PARTS & SERVICE NEWS

REF NO. AA99096

SUBJECT: HYDRAULIC TUBE BRACKET MODIFICATION OR REPLACEMENT

APPLICATION: WA800-2L WHEEL LOADER WITH S/N A20001 THRU A20019
WA800-2LC WHEEL LOADER WITH S/N A20020 THRU A20023
WA900-1L WHEEL LOADER WITH S/N A20001 THRU A20007
WA900-1LC WHEEL LOADER WITH S/N A20008 THRU A20014

L10AD154

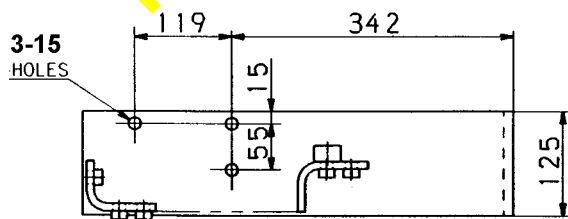
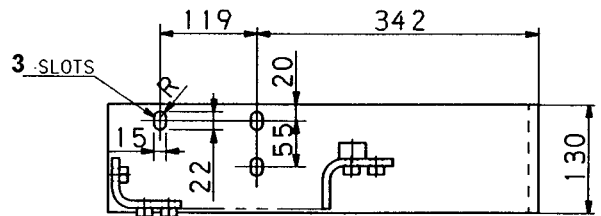
You will have a choice of using the new bracket or modifying the existing bracket.

OLD BRACKET

NEW BRACKET

L10AD155

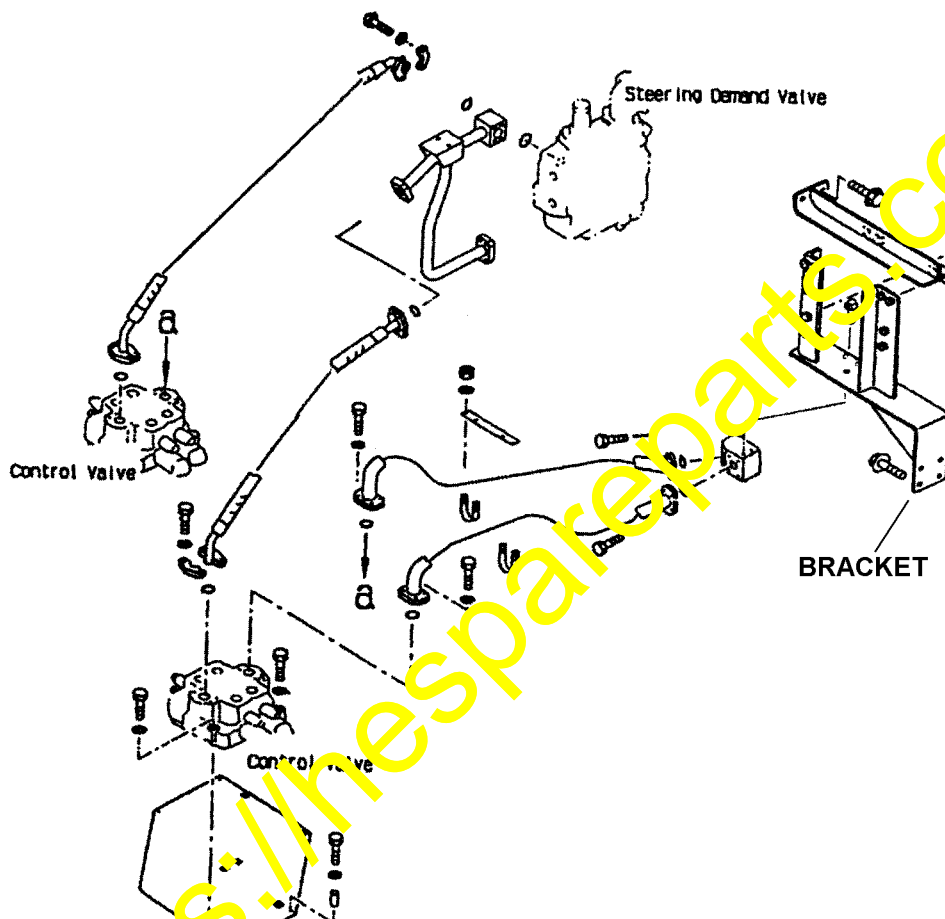
1. Remove the bracket from the front frame.

TOP VIEW OF BRACKET

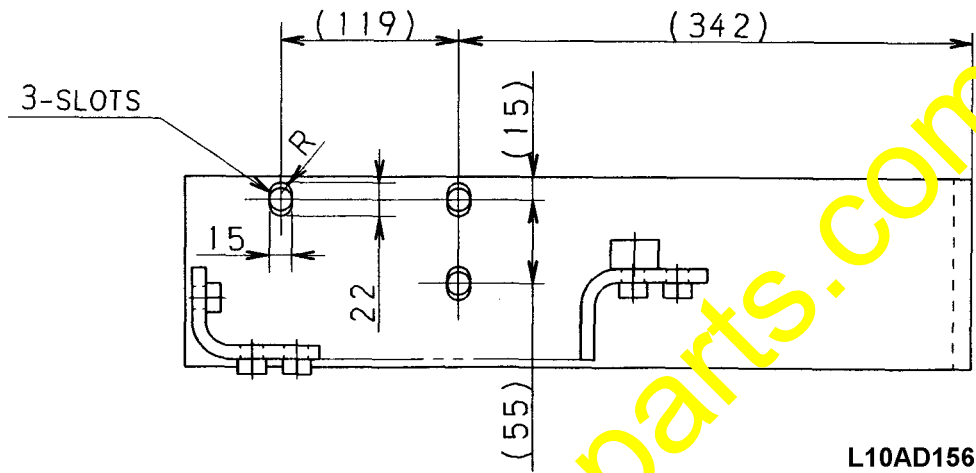
- To modify the existing bracket, make slots in the 3-15 holes in the bracket.

3. Install the new or modified bracket to the frame.
4. Install the tubes, A and B, to the junction, C. Make sure the tubes, A and B, are not stressed after installation.
5. Install the plate, D.
6. Bleed the air from the hydraulic circuit. If needed, refer to the O & M manual, section 24.2.16.
